**USDOE Hanford Site**  
**First Five Year Review Report**

Prepared by:  
The U.S. Environmental Protection Agency  
Region 10, Hanford Project Office

April 2001

Figure 200-9. Gable Mountain Pond Baseline Strontium-90 Contours.

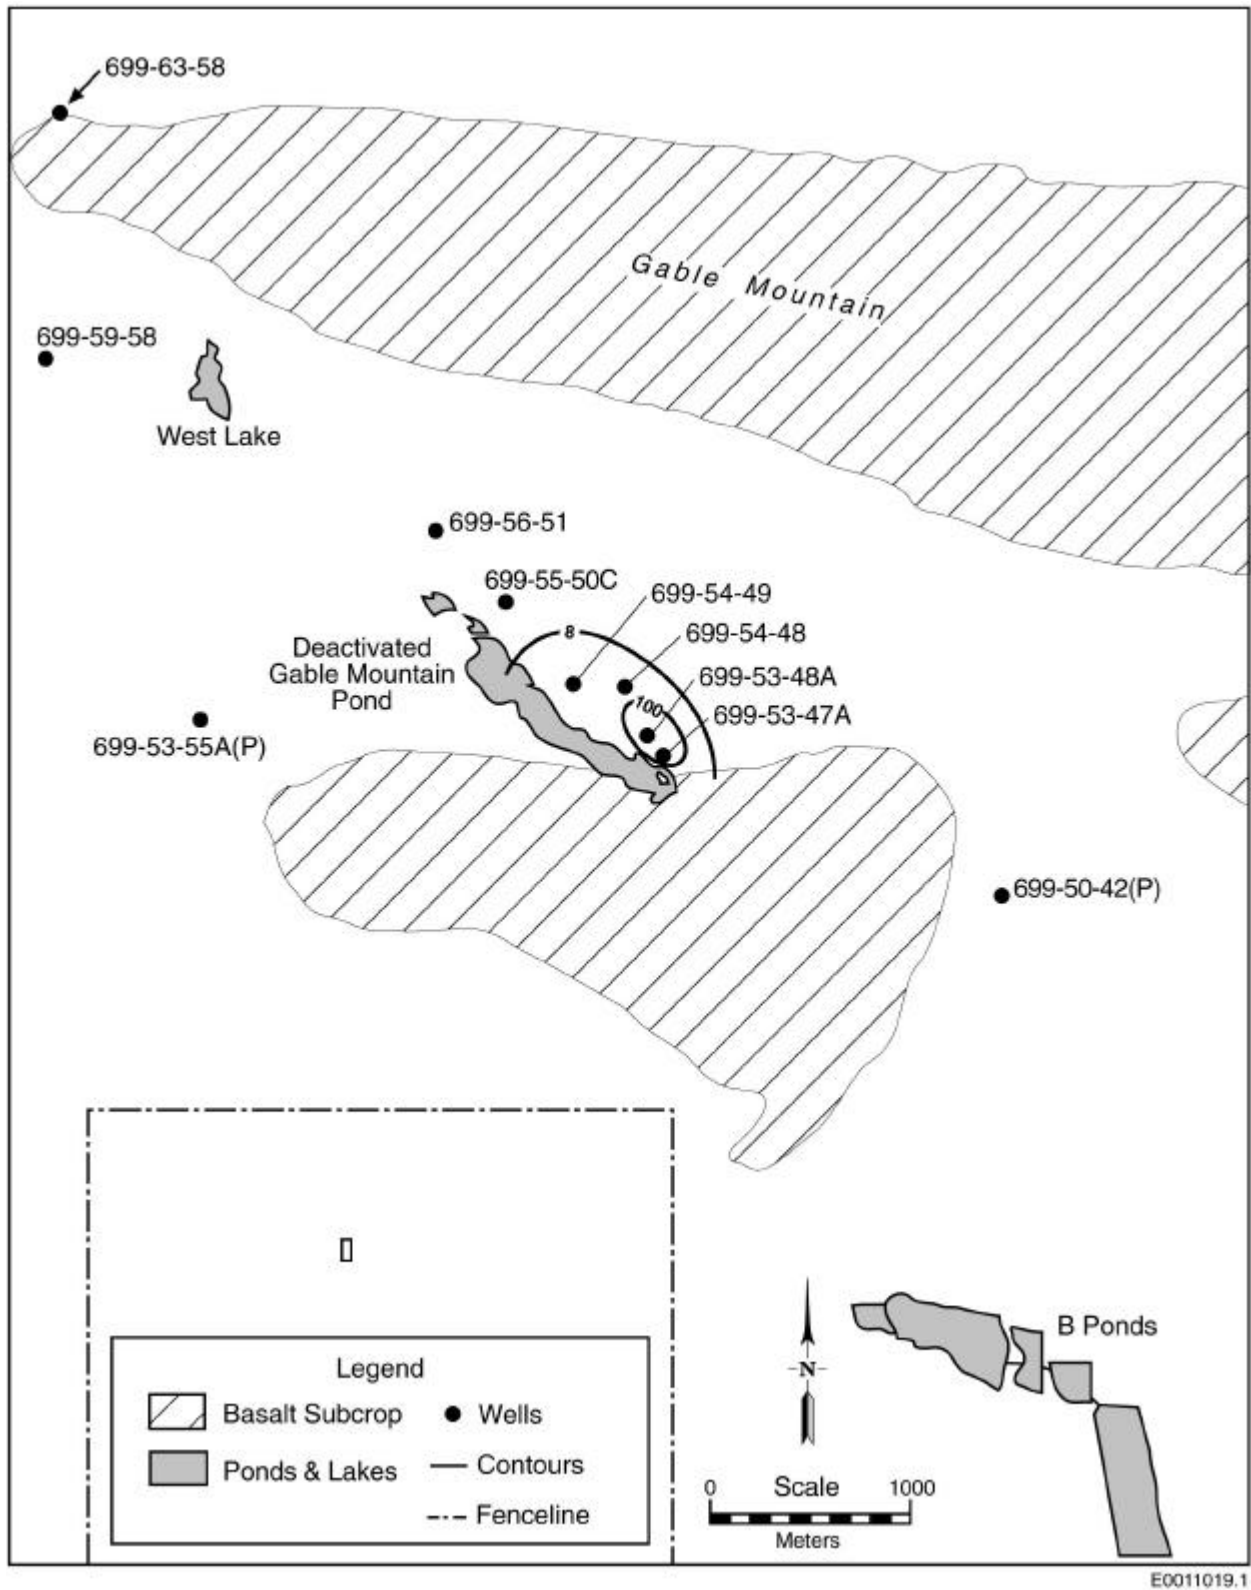
5. Page 200-18, Figure 200-9

**Figure 300-2. 300 Area Operable Unit Boundaries.**

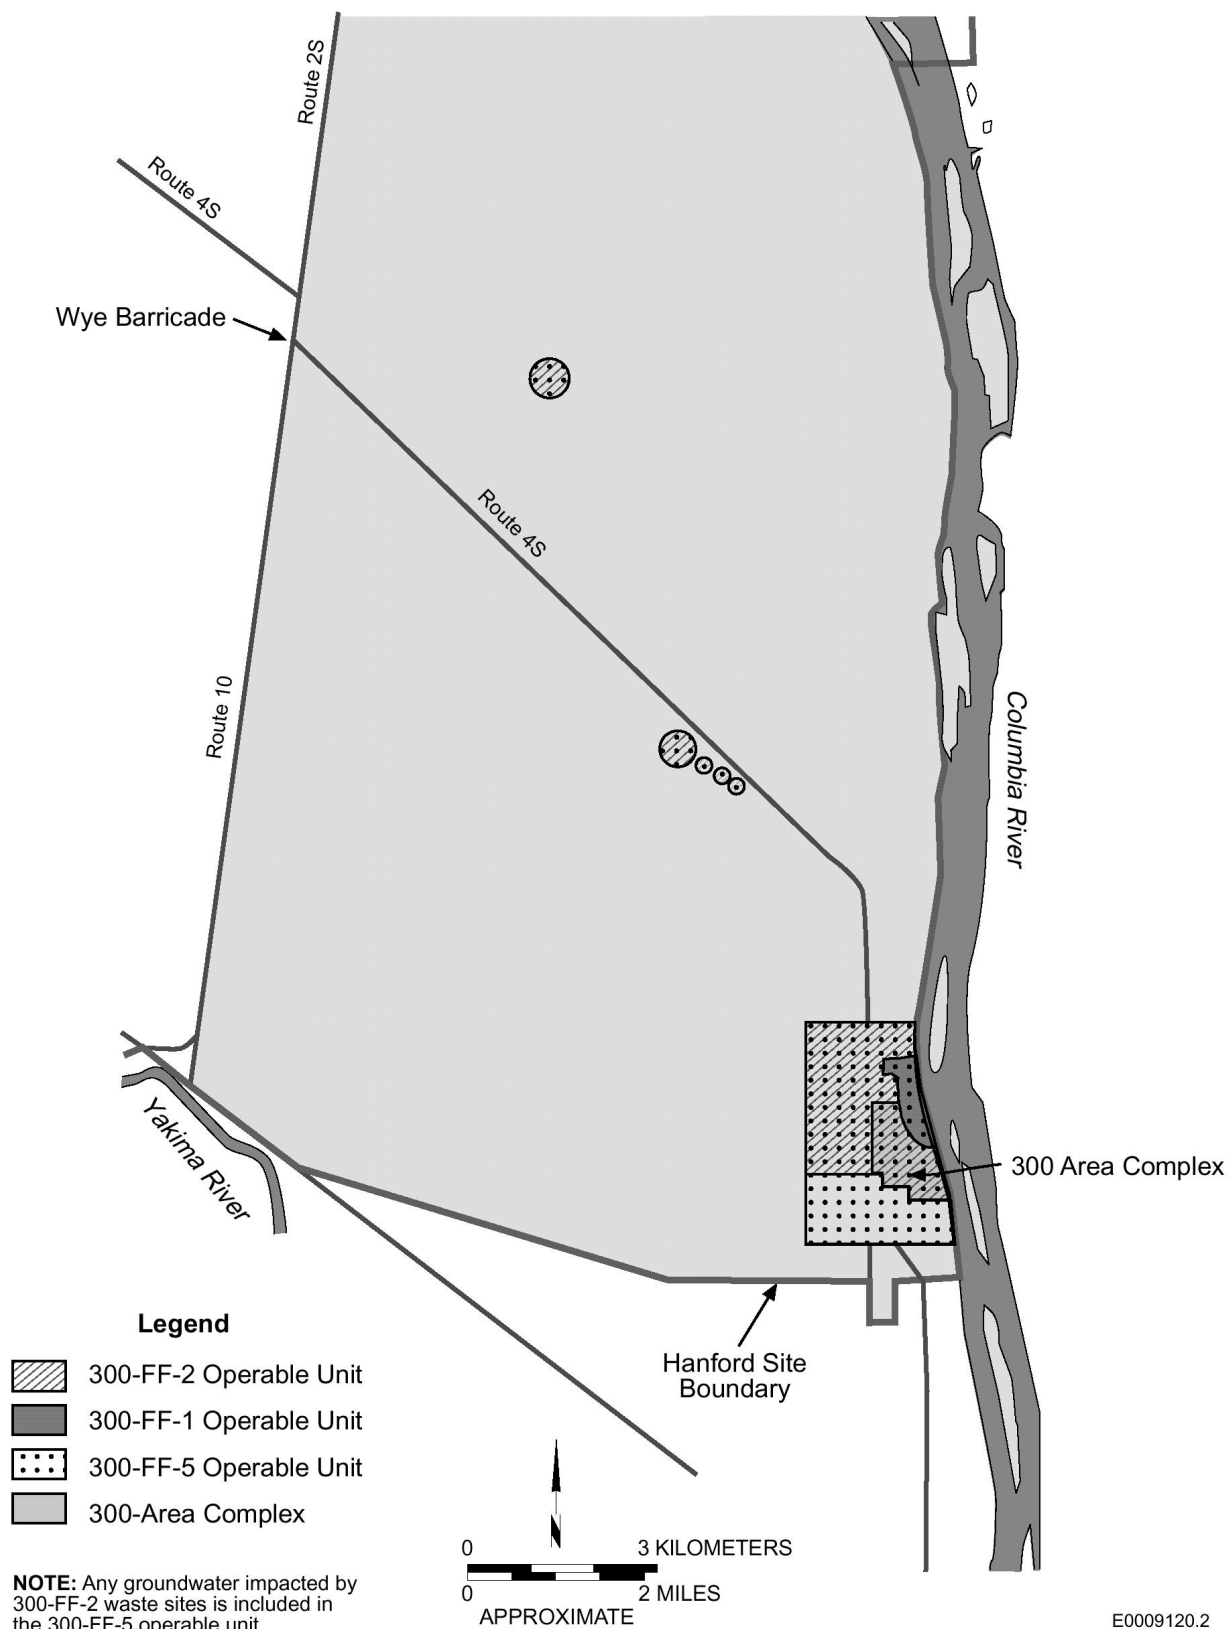
The 300 Area was listed on EPA's NPL in 1989 and consists of three operable units. Figure 300-2 depicts the boundaries of the 300 Area operable units. The 300-FF-1 and 300-FF-2 Operable Units address soil contamination areas and burial grounds associated with operations in the 300 Area. The 300-FF-5 Operable Unit addresses groundwater contamination beneath the burial grounds and soil waste sites (Figure 300-3) The primary contaminant in the 300 Area is uranium from the fuel fabrication process. However, other potential contaminants exist for individual waste sites because of the diverse uses of the 300 Area. The primary cleanup actions involve the removal of contaminated soils and debris; treating the material, as appropriate, to reduce the toxicity, mobility, or volume of wastes; and disposing of the material in an appropriate long-term waste management facility. The majority of waste from cleanup of the 300 Area will be disposed of at the Environmental Restoration Disposal Facility (ERDF) in the 200 Area of the Hanford Site. An industrial exposure scenario is being used as the basis for evaluating risk and establishing cleanup levels in the 300 Area, consistent with the reasonably anticipated future land use for this portion of the Hanford Site. The 300-FF-5 Operable Unit includes groundwater contamination beneath the soil waste sites and burial grounds. The current decision for contaminated groundwater in the 300 Area is to monitor the groundwater to ensure that contamination levels are attenuating through natural processes in a reasonable time frame.
